REMARKS

This is a full and timely response to the non-final Office Action (Paper No. 2) mailed by the U.S. Patent and Trademark Office on September 27, 2002. Upon entry of the attached amendments, claims 1-12 have been amended, claims 13, 14, and 15 have been canceled without prejudice, waiver, or disclaimer. Claims 1-12 are hereby amended to more particularly point out and distinctly claim the subject matter that Applicant regards as the invention. No new matter is added. Reconsideration of the pending claims is respectfully requested, in view of the changes as denoted in the attached appendix and the following remarks. Each objection and rejection presented in the Office Action is discussed in the remarks that follow.

APPENDIX D - AMENDMENTS TO THE DRAWINGS

FIG. 1

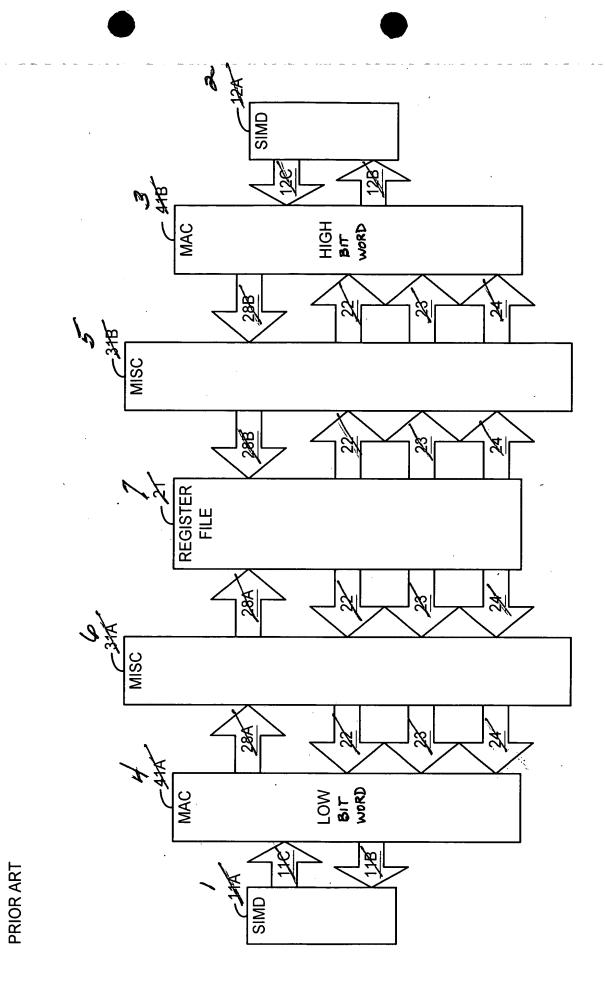
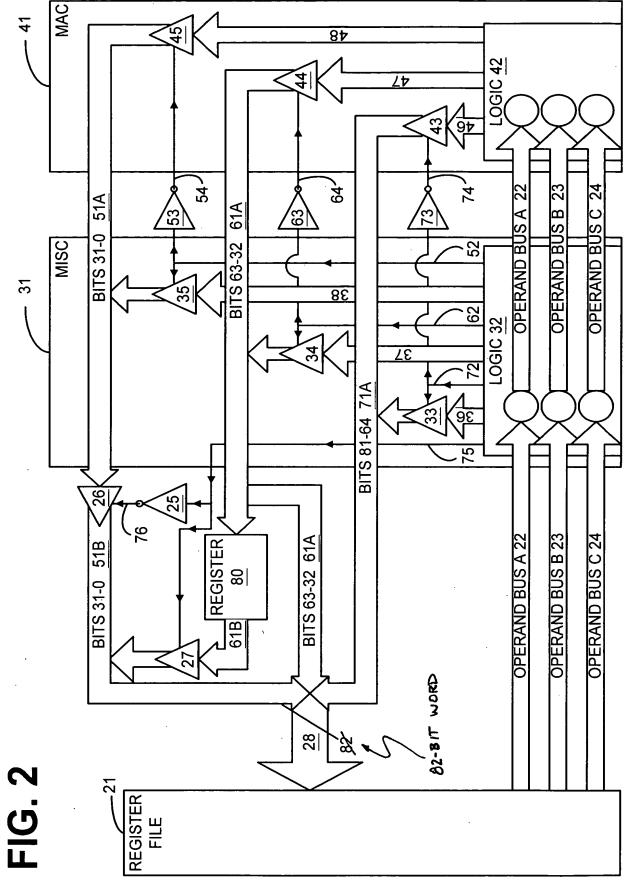
The drawings are objected to for allegedly failing to comply with 37 C.F.R. 1.84(p)(5) because they do not include reference numerals mentioned in the description and because they include other reference numerals not mentioned in the description.

Proposed drawing corrections are included in Appendix D for review and acceptance by the Examiner. Applicant has amended the Drawings to include reference numerals for items discussed in the detailed description and amended the Drawings to remove reference numerals from items not discussed in the specification. Accordingly, upon entry of the amendments and acceptance of the proposed substitute drawings as included in Appendix E, the objection is rendered moot.

Please find enclosed a redlined copy showing the proposed changes to the drawings.
